APPLICATION NO.	FILING DATE	FIRST NAMED INVENTOR	ATTORNEY DOCKET NO.	CONFIRMATION NO.
10/082,808	02/22/2002	Doron Kreiser	BEL1030U	2056
25197	7590	06/16/2004	EXAMINER	
LEARY & ASSOCIATES 3900 NEWPARK MALL RD. THIRD FLOOR, SUITE 317 NEWARK, CA 94560			NATNITHITHADHA, NAVIN	
			ART UNIT	PAPER NUMBER
			3736

Office Action Summary	Application No.		Applicant(s)	
	10/082,808		KREISER ET AL.	
	Examiner		Art Unit	
	Navin .Natnithithadha		3736

DETAILED ACTION

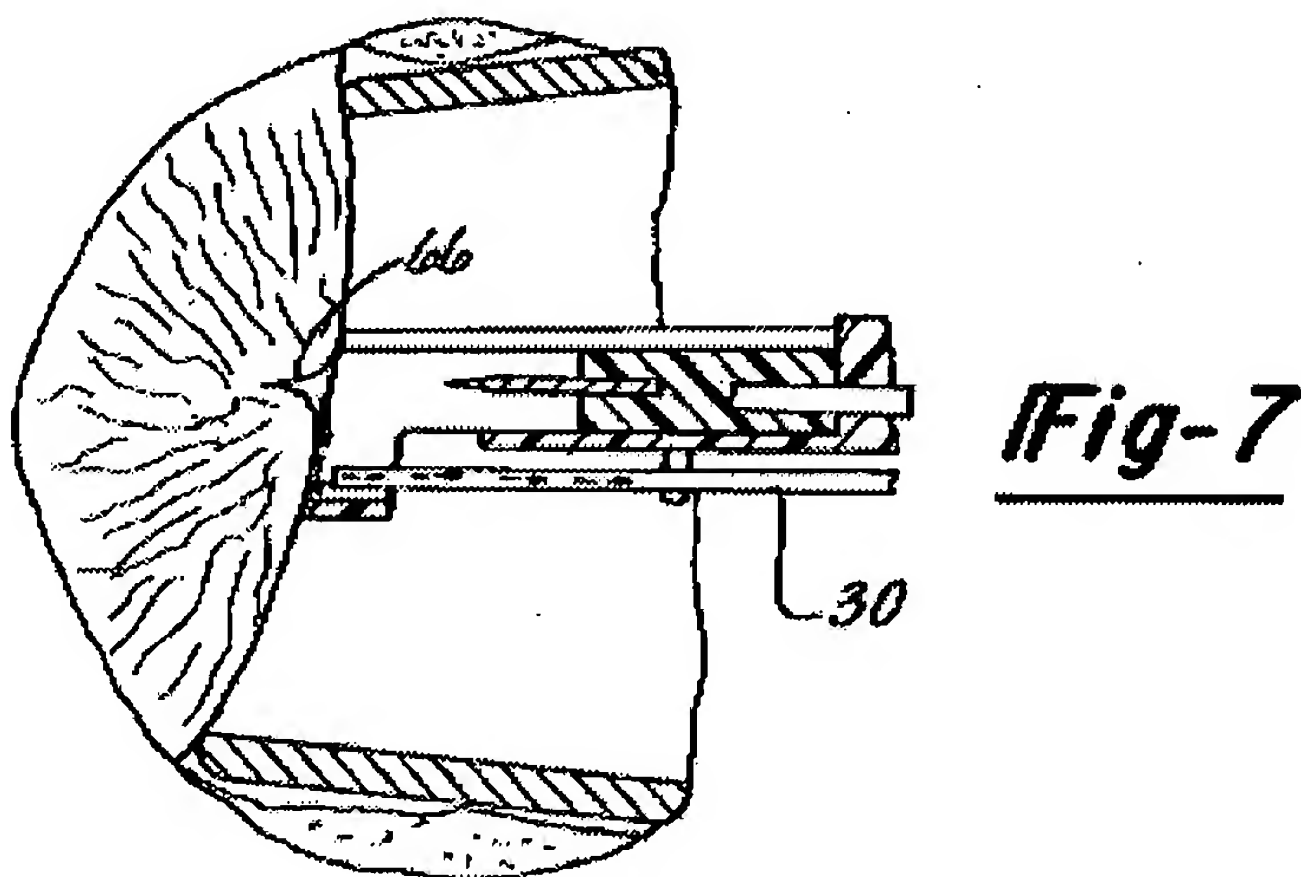
Claims 1 and 2: Sarrine discloses a device 10 for measuring fetal blood pH (see col. 1, lines 10-27), comprising: a lancet 40 extendable from a distal end of the device for incising tissue (see fig. 4 below); and a capillary 30 at the distal end of the device for collecting a sample of blood for pH analysis (see fig. 1 and 7 below).

Sarrine discloses the capillary 30 is in a fixed position (see col. 2, lines 59-62) and not extendable from the distal end of the device 10. After the incision of the tissue, blood flows downward and into the fixed capillary tube (see fig. 7 below).

Fig. 64

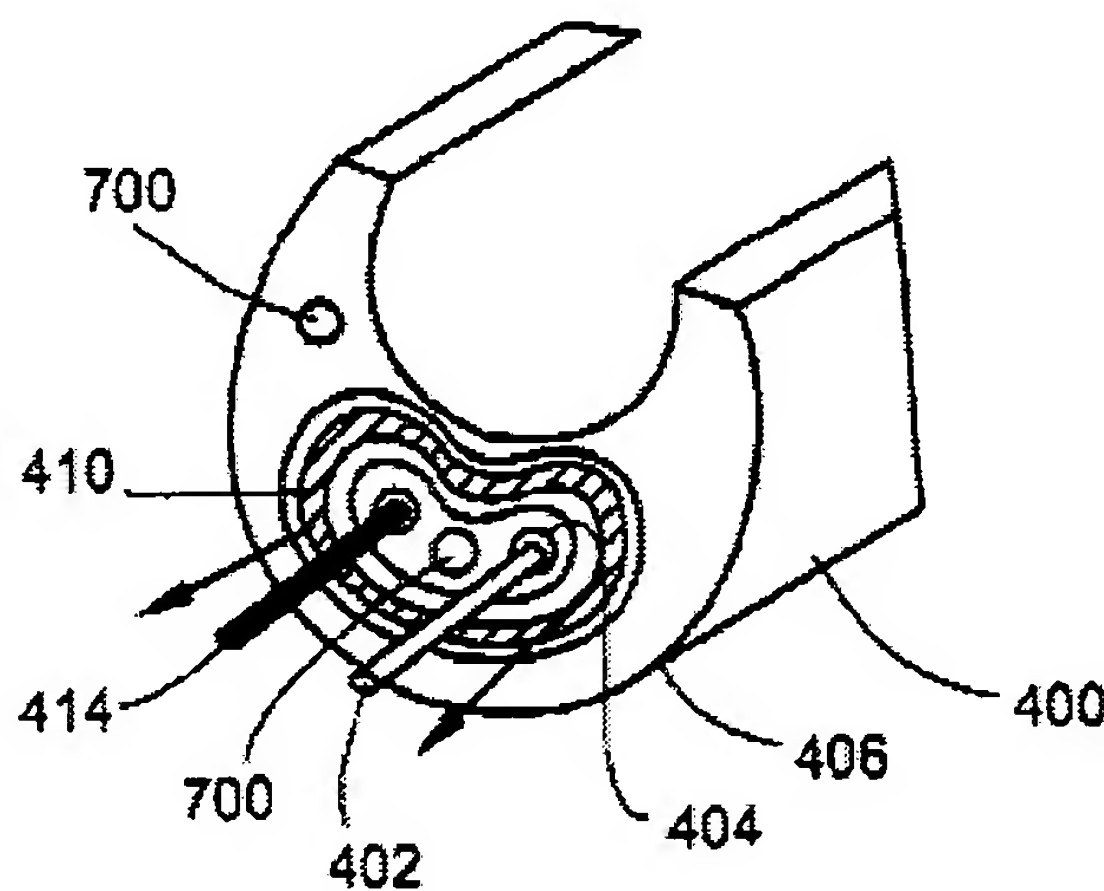
However, Levy et al discloses a device comprising: a lancet 414 extendable (ejectable) from a distal end of the device for incising tissue (see fig. 64 below and col. 21, lines 46-55); and a capillary 402 extendable (ejectable) from the distal end of the device for collecting a sample of blood (see col. 21, lines 25-35). It would have been obvious for one of ordinary skill in the art at the time the invention was made to modify Sarrine's device to have both a lancet and a capillary extendable from the distal end of the device in order to effectively sample blood from any position of the device.

Claims 5 and 7: Levy et al discloses a lancet (puncturing device) 414 and capillary 402 are slidably (ejectably) mounted in a guide tube (sleeve) 410 (see fig. 64 above).

The guide tube 410 is shown in figure 64 as being one body having two tubes, in which both tubes can be considered a lancet guide tube and a capillary guide tube.

Fig. 1

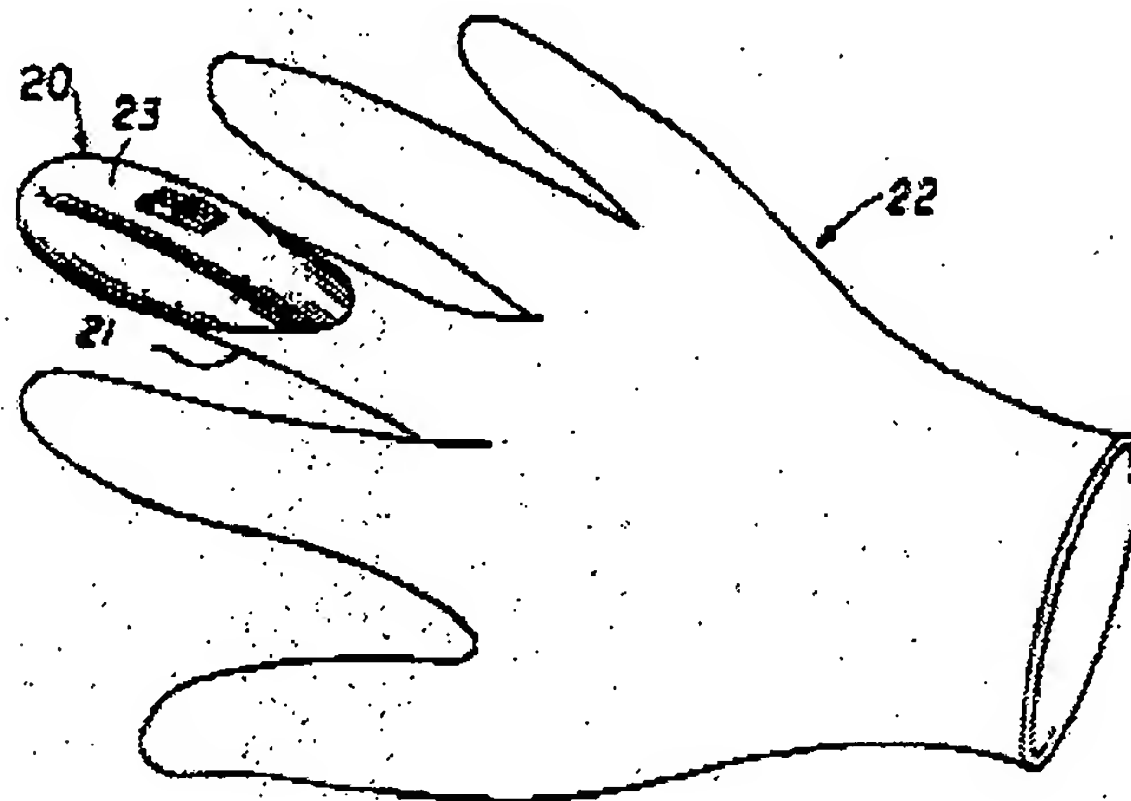
Sarrine discloses a handle type member 14 and not a means for mounting the device to an operator's hand in the form of a surgical glove. However, Salterwhite discloses a device comprising: a means 22 for mounting the device to an operator's hand in the form of a surgical glove 22 (see figs. 1 and 5); and a lancet 42 extendable from a distal end of the device for incising tissue. It would have been obvious for one of ordinary skill in the art at the time the invention was made to modify Sarrine's device to be mounted

on an operator's hand in the form of a surgical glove in order to more easily place a lancet at an incision site.

Fig. 1

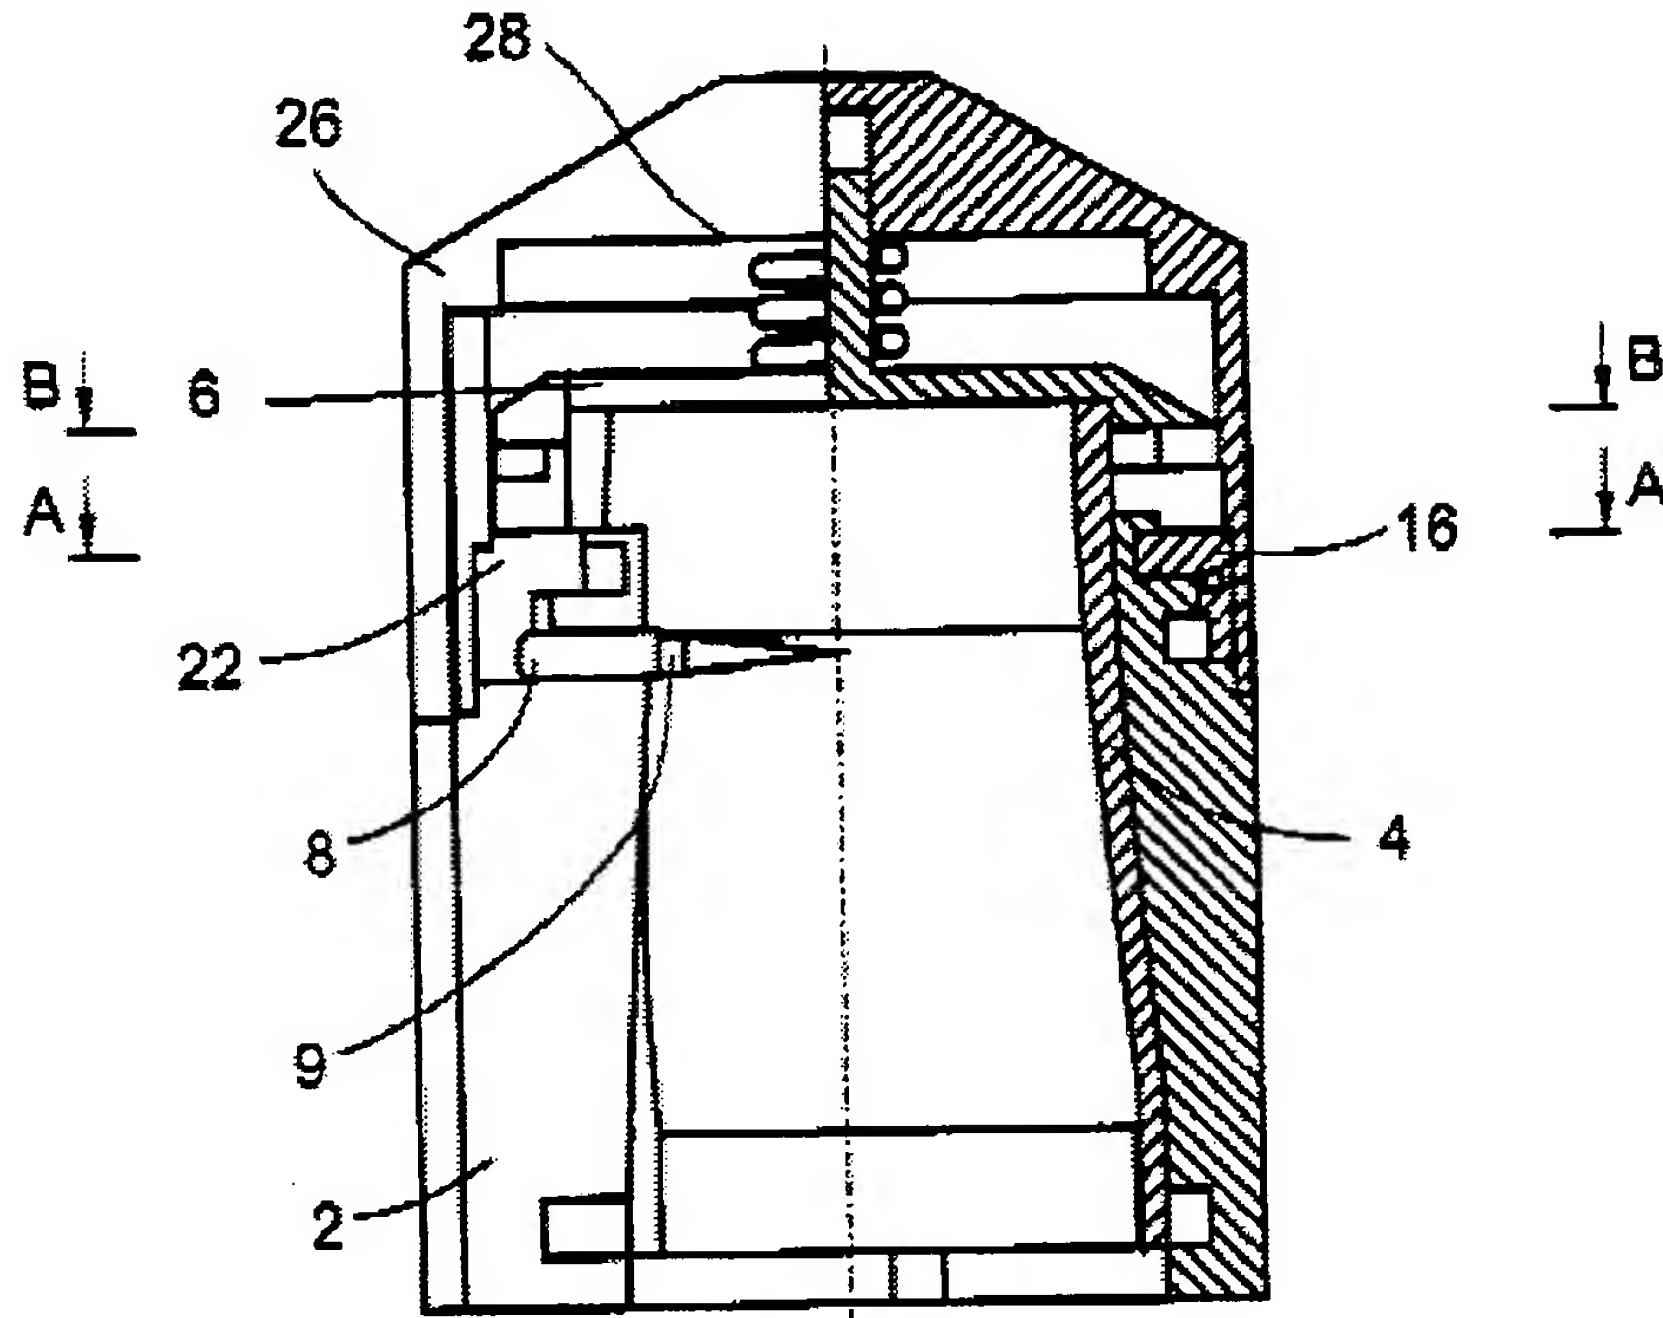
discloses the capillary 30 is in a fixed position (see col. 2, lines 59-62) and not extendable from the distal end of the device 10. After the incision of the tissue, blood flows downward and into the fixed capillary tube (see fig. 7 above). Also, Sarrine discloses a handle type member 14 and not a means for mounting the device to an operator's hand in the form of a finger cot or a finger ring. However, Levy et al discloses a device (see fig. 1 above) comprising: a means 4 for mounting the device to an operator's hand in the form of a finger cot (thimble-like finger grip) 4 (see fig. 1 below and col. 13, lines 25-30) or a finger ring 400 (see fig. 63 below and col. 21, lines 11-32); a lancet (needle or puncturing device) 8/414 extendable from a distal end of the device for incising tissue (see col. 21, lines 46-55); and a capillary 402 extendable from the distal end of the device for collecting a sample of blood (see col. 21, lines 25-35). It would have been obvious for one of ordinary skill in the art at the time the invention was made to combine Sarrine's device with that of Levy et al's device in order to more easily place a lancet and capillary at an incision site.
